CITY PLANNING COMMISSION

- APPLICATION:
1. Environmental Determination
 2. Special Permit to develop 82 townhouse units
 3. Subdivision Modification to waive street improvements for Lot 'B'
 4. Tentative Map

PROPOSAL: The applicant is requesting the necessary entitlements to develop 82 townhouse units on 8.18± vacant acres to be known as "The Village."

P83-156

(REVISED PER SRC HEARING)
 Tentative Map • ASSESSORS PARCEL #2
 117-140-21
THE VILLAGE

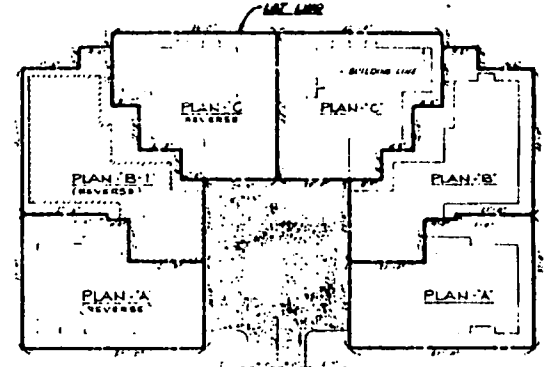
- 2. The proposed development consists of 15 clusters of three to six units each. Due to the clustering of the units, application of north/south lot orientation is meaningless relative to solar access. However, the project achieves 80 percent north/south lot orientation.

This parkland dedication requirement may be reduced by as much as 40 percent once definite plans are developed for the "pool recreation area" noted on the tentative map. This is because the Parkland Dedication Ordinance allows for credit for on-site recreational facilities. To assess the credit given, staff recommends that the applicant submit schematic plans prior to the filing of the final map and detailed plans prior to issuance of building permits for staff review and approval.

6. The proposed reduction in the required street setback on Calvine Road from 25 feet to as little as 17 feet four inches is justifiable in light of the fact that the frontage is opposite the edge of the Consummes River College campus, including a portion of a depressed parking area. Additionally, the condominium units along Calvine Road will vary in setback to as much as 35 feet from the front property line.

1. Ratification of the Negative Declaration;
2. Approval of the Special Permit, subject to conditions and based upon Findings of Fact which follow;
3. Approval of the Subdivision Modification to waive street improvements for Lot 'B' only; and
4. Approval of the Tentative Map, subject to the following conditions:
